2ND AND VIRGINIA

RESPONSE TO LPB PRIORITIES 21

LPB PRIORITIES

MEETINGS RECAP

TSA PARTY WALL ELEVATION CHANGES
RE-WORKED WINDOW PATTERNING + SCALE

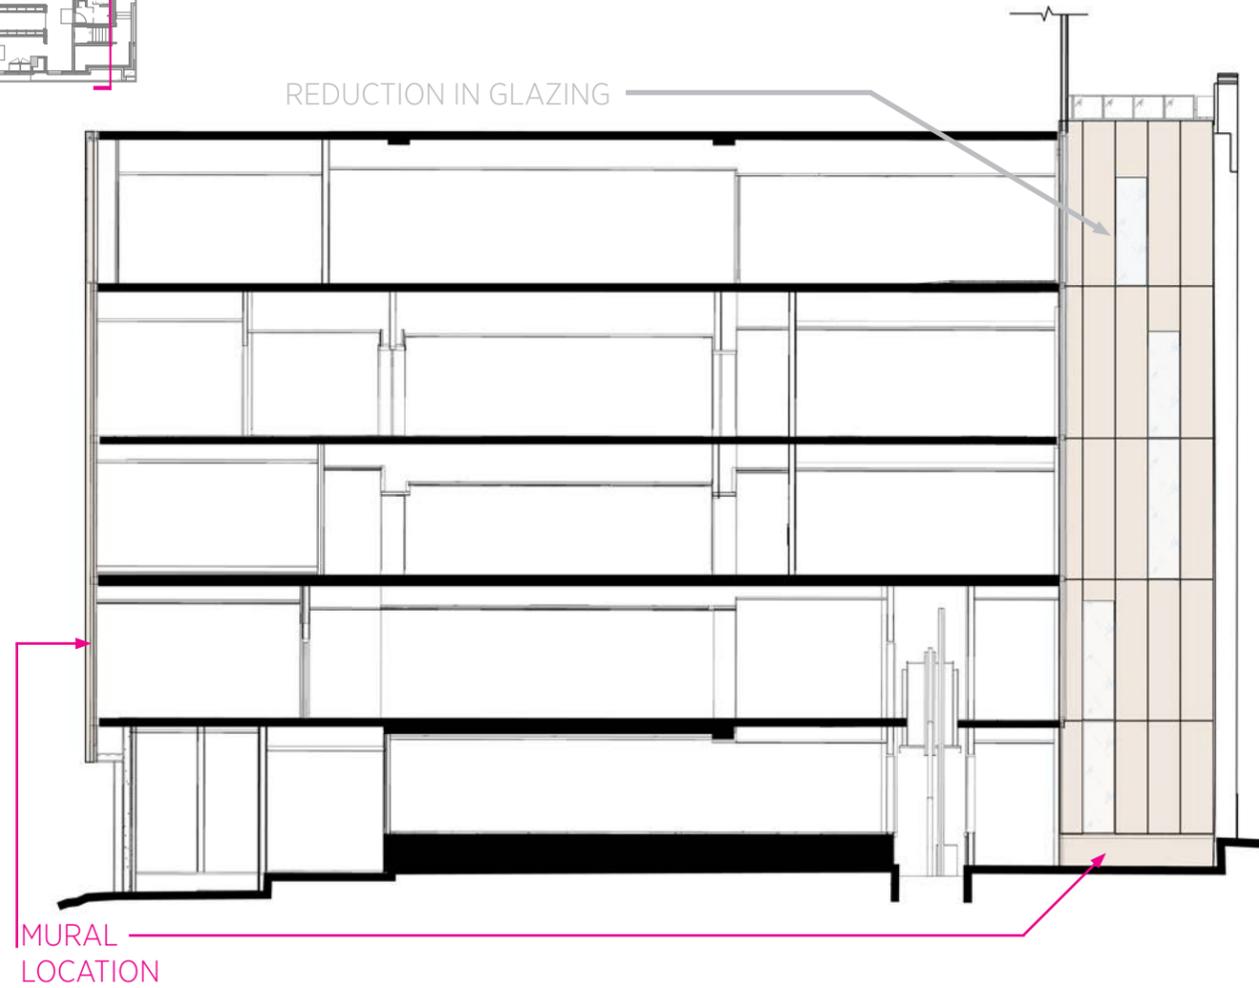
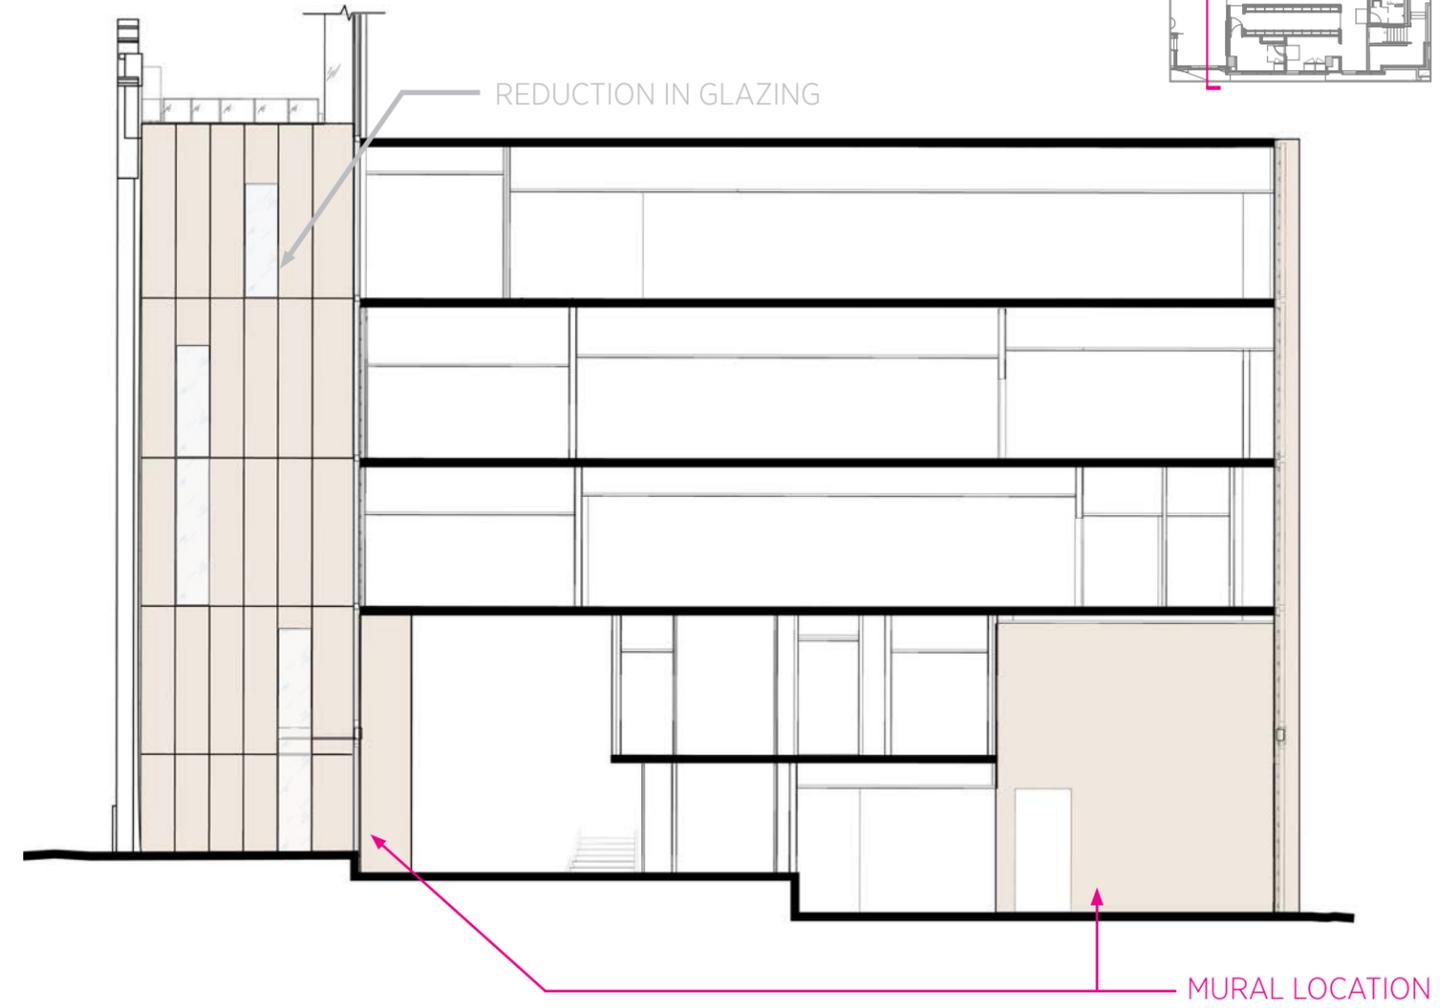
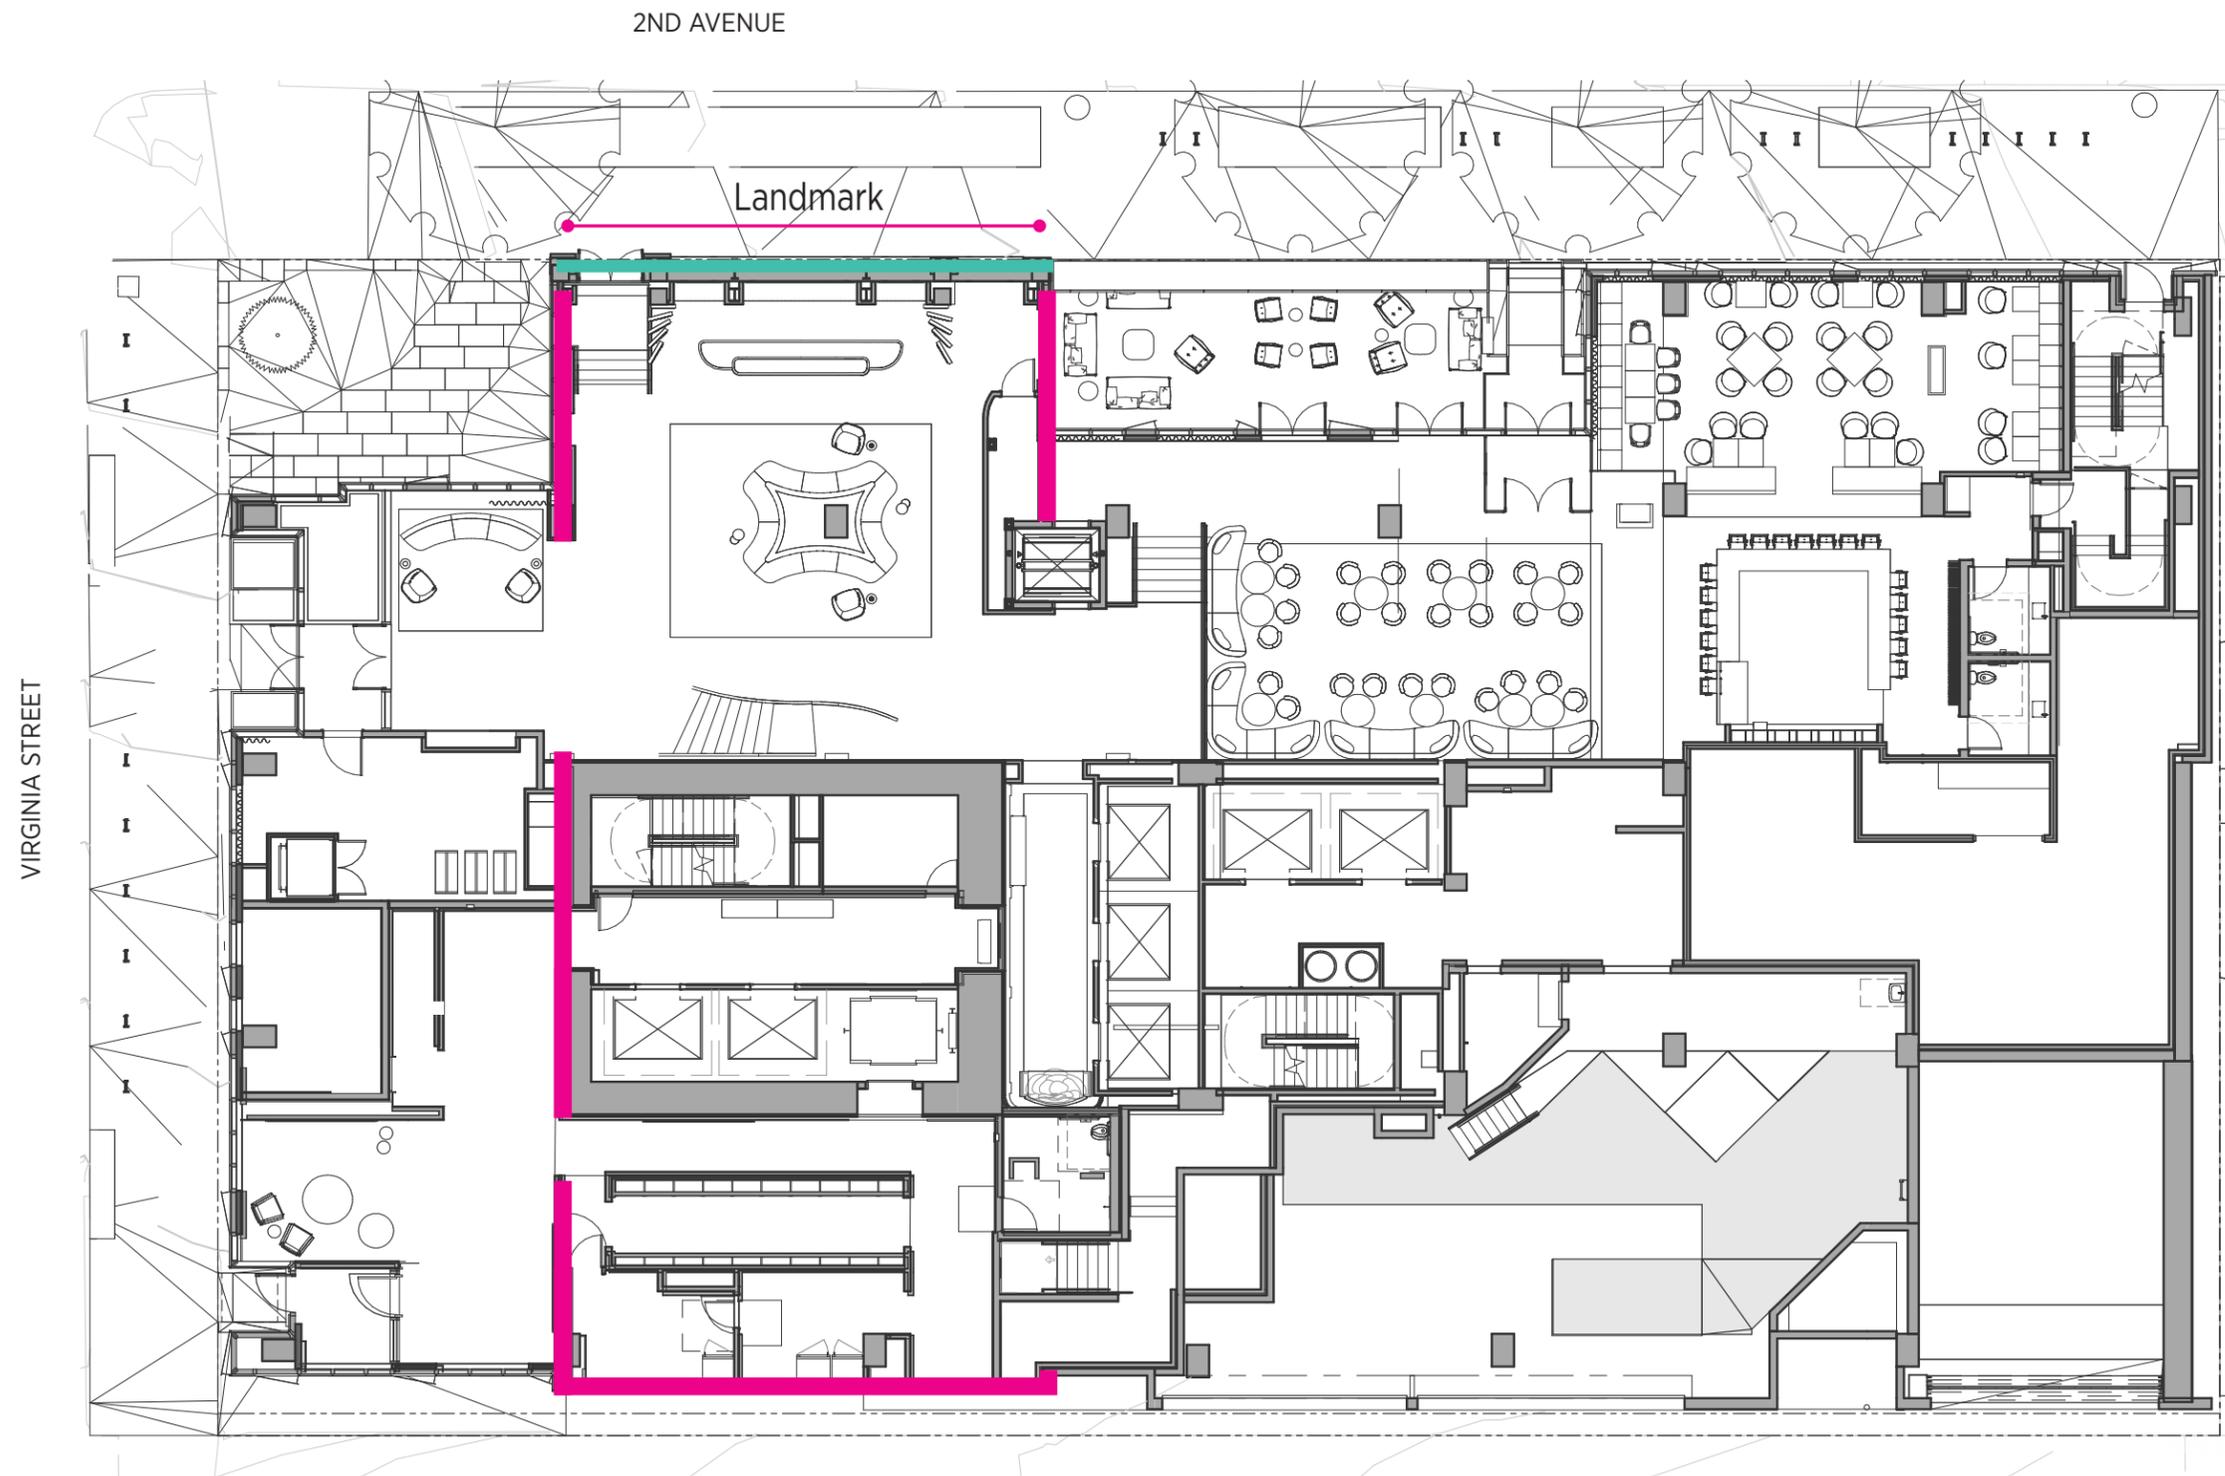
ARC #7 Feedback: Show mural continuity as volume expression

REDUCTION IN GLAZING

REDUCTION IN GLAZING
